RESOLUTION SETTING HEARING ON REQUEST FROM FT. DES MOINES RENOVATION, LLC (OWNER) FOR AMENDMENT TO THE WEST POINT SOUTH PUD CONCEPTUAL PLAN FOR REDEVELOPMENT AT 6700 CHAFFEE ROAD

Communication from the City Plan and Zoning Commission advising that at their meeting held May 7, 2015, the following action was taken regarding a request from Ft. Des Moines Renovation, LLC (owner) represented by Justin Doyle (officer) for review and approval of an amendment to the West Point South PUD Conceptual Plan on property located at 6700 Chaffee Road.

APPROVAL of the requested amendment to the West Point South PUD Conceptual Plan subject to providing the following revisions: (ZON2015-00061)

SHEET NAME
PLAN MAP

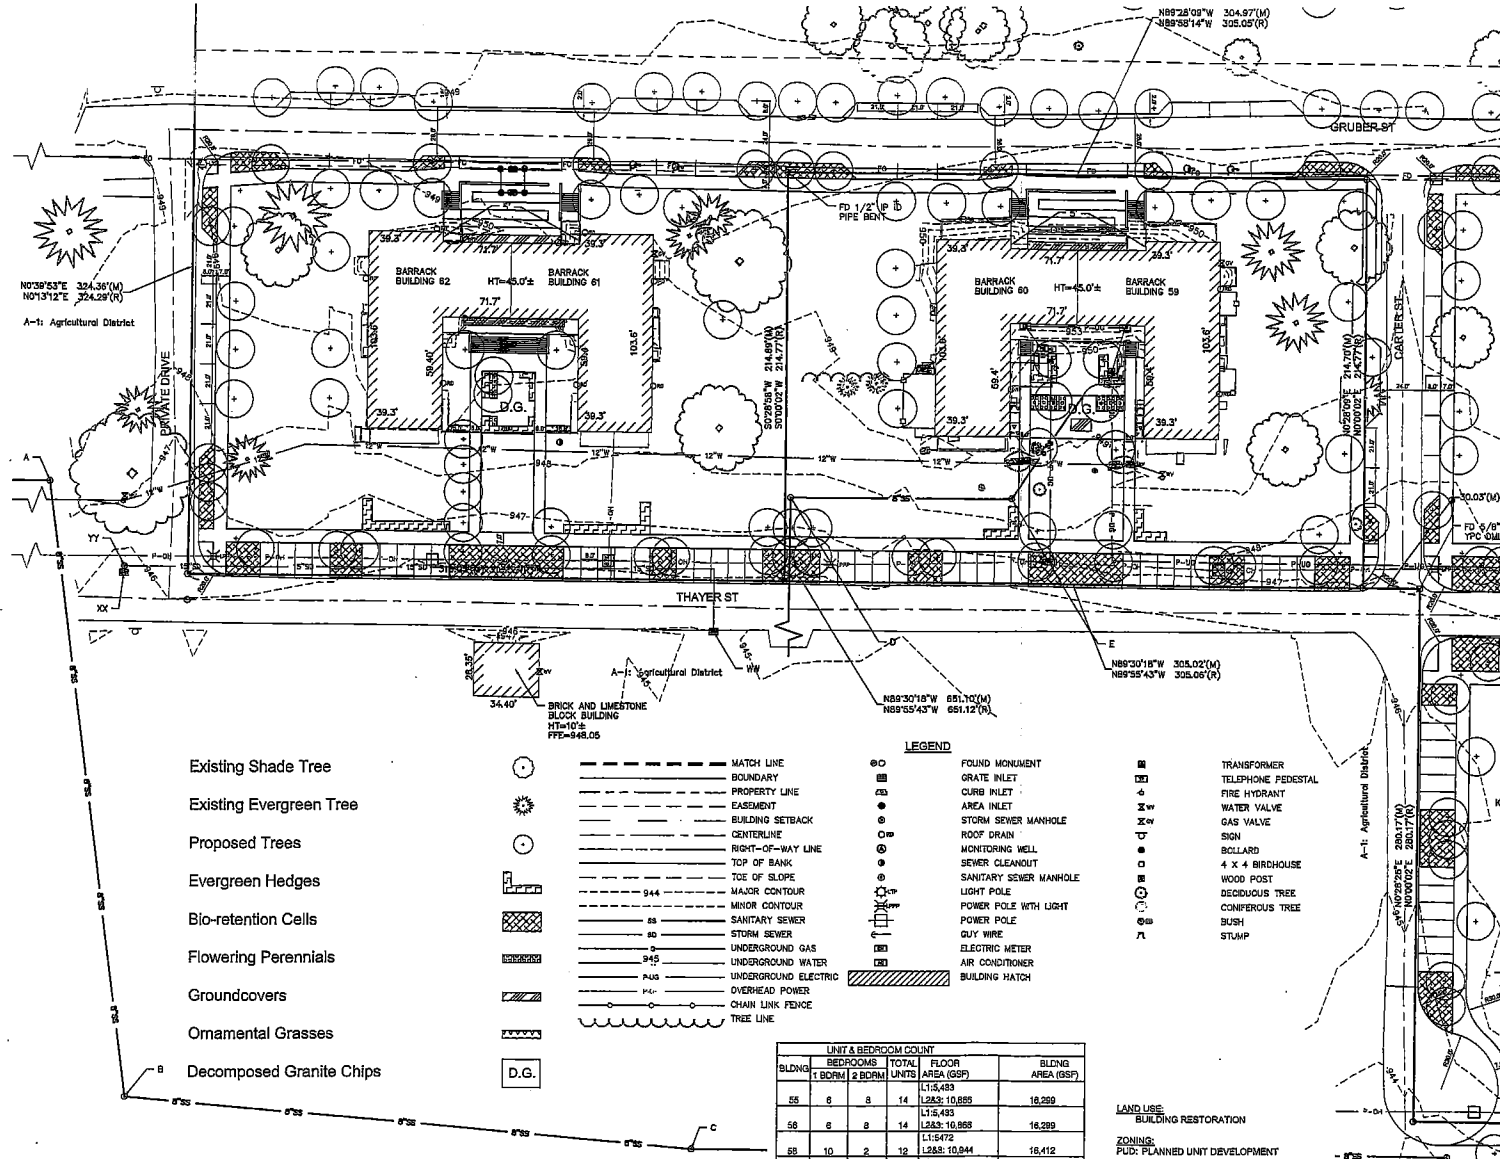
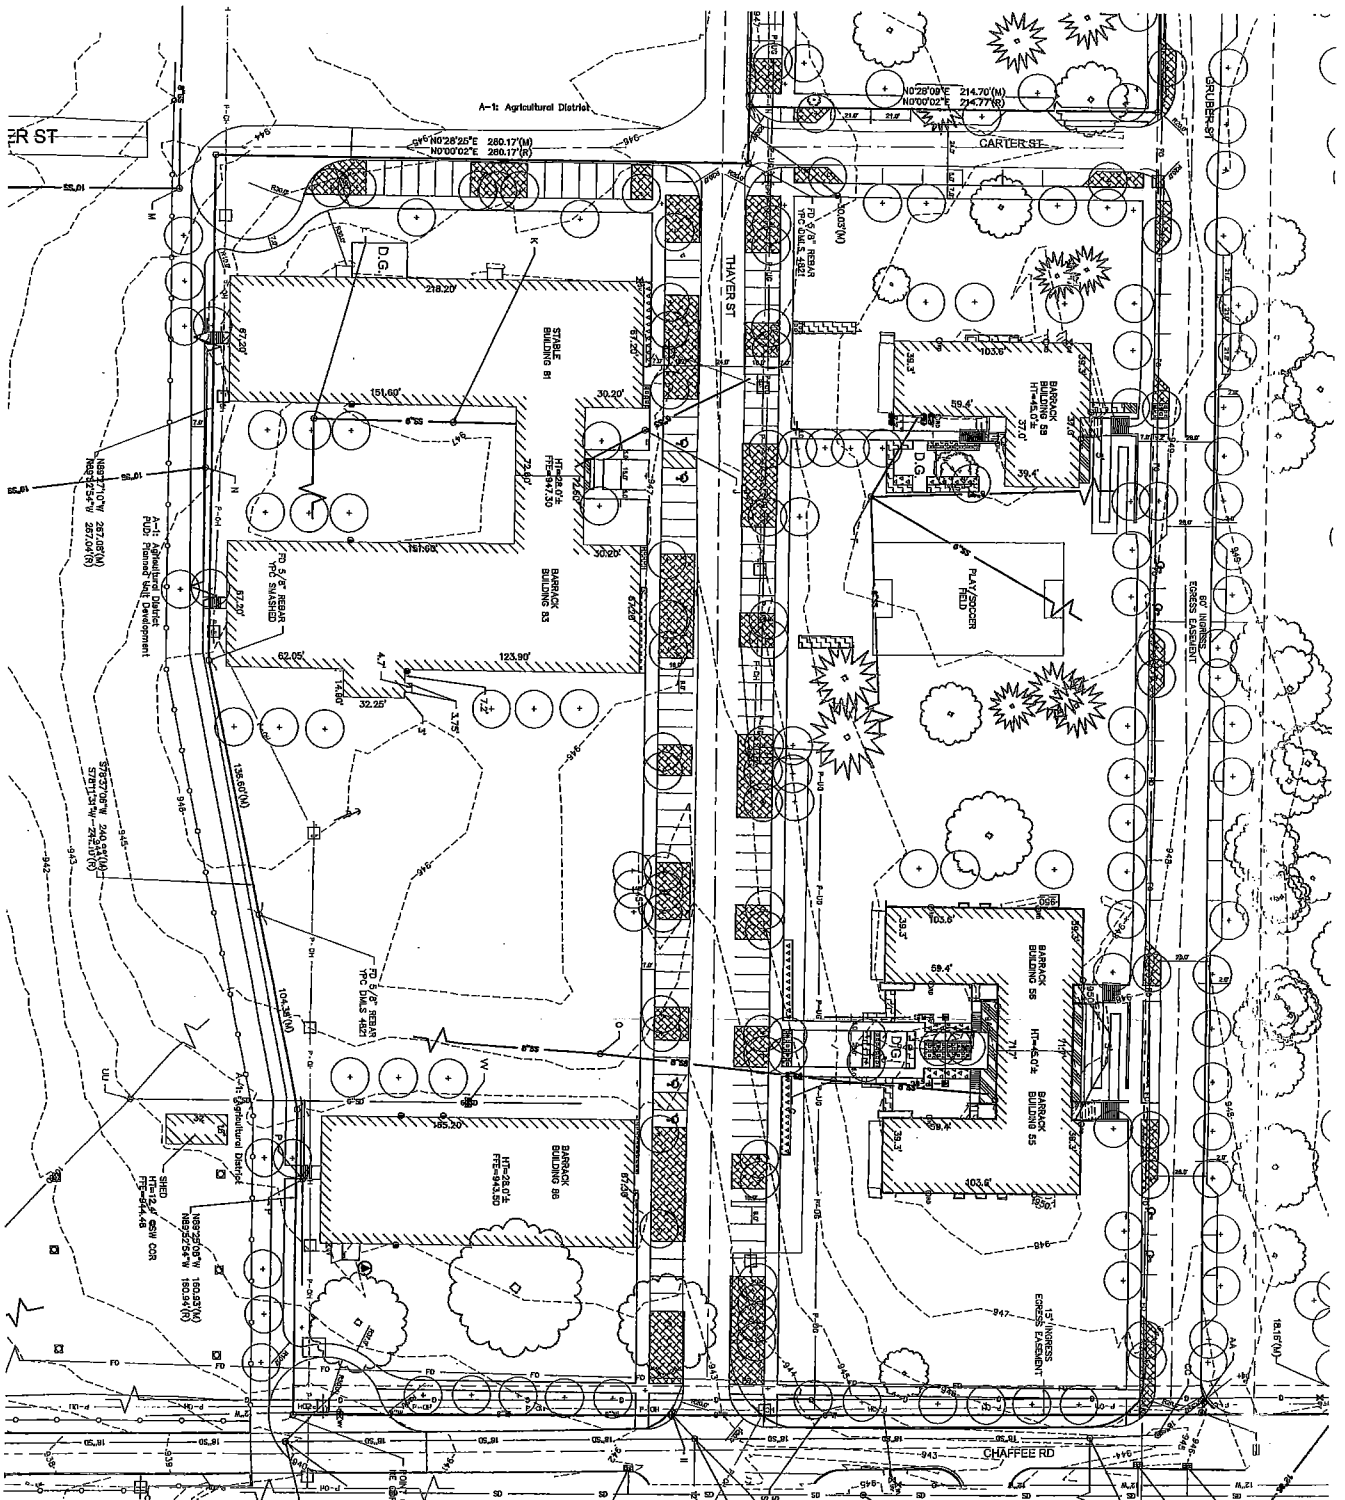
6. **Access or Parking:** 190 off-street parking stalls are currently being proposed within the site. This is below the typical requirement for 1.5 spaces per unit which would require 245 spaces. Staff is concerned that the number of parking spaces could be deficient. Based on this concern, the applicant has indicated the intent to provide 198 spaces or eight additional to what was submitted with the Conceptual Plan. This is equivalent to 1 space per 1-bedroom unit and 1.5 spaces for 2-bedroom unit. Staff recommends that approval be subject to this standard.

1. Compliance with all administrative comments prior to finalization of the record Mylar by the Planning Administrator.
2. Addition of an off-street parking requirement for a minimum of 198 parking spaces, (at a standard of one space per one bedroom unit and 1.5 spaces per two bedroom unit).
